EXPANSION & RENOVATE AS NEW – PHASE 1

**CRYSTAL LAKE ELEMENTARY SCHOOL  
284 SANDY BEACH ROAD  
ELLINGTON, CT 06029  
STATE PROJECT NO. 048-0058 EA/RR/PS**

**DATE: January 9, 2014**

The following changes to the Drawings and Project Specifications shall become a part of the Drawings and Project Specifications; superseding previously issued Drawings and Project Specifications to the extent modified by Addendum No. 7.

Head Detail  
Area "A"

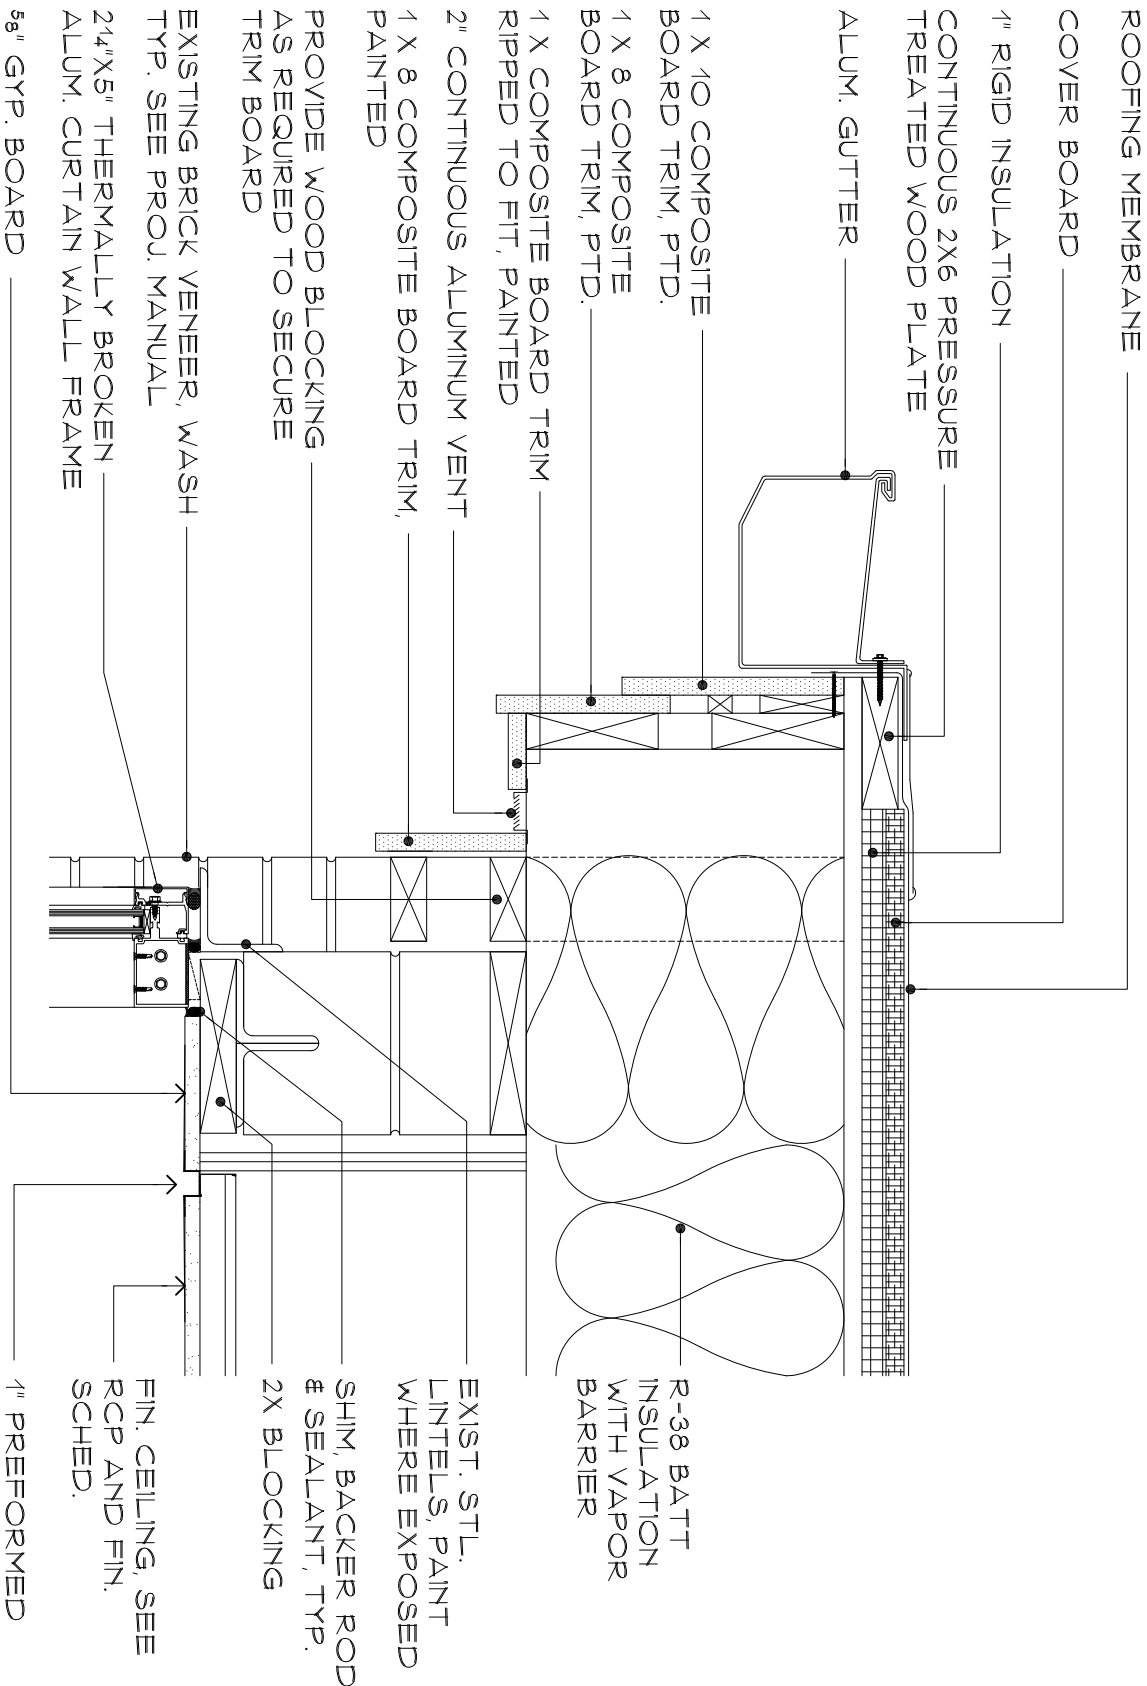
- DRAWING SKA6, READING/LANGUAGE ELEVATIONS has been added and is attached as part of this addendum. This detail adds information to Drawing A722.
- DRAWING SKA7, HEAD DETAIL AREA ‘A’ has been added and is attached as part of this addendum. This detail adds information to Drawing A552.
- DRAWING SKA8, JAMB DETAIL AREA ‘A’ has been added and is attached as part of this addendum. This detail adds information to Drawing A630.
- DRAWING SKA9, JAMB DETAIL AREA ‘A’ has been added and is attached as part of this addendum. This detail adds information to Drawing A630.
- DRAWING SKA10, JAMB DETAIL AREA ‘A’ has been added and is attached as part of this addendum. This detail adds information to Drawing A630.
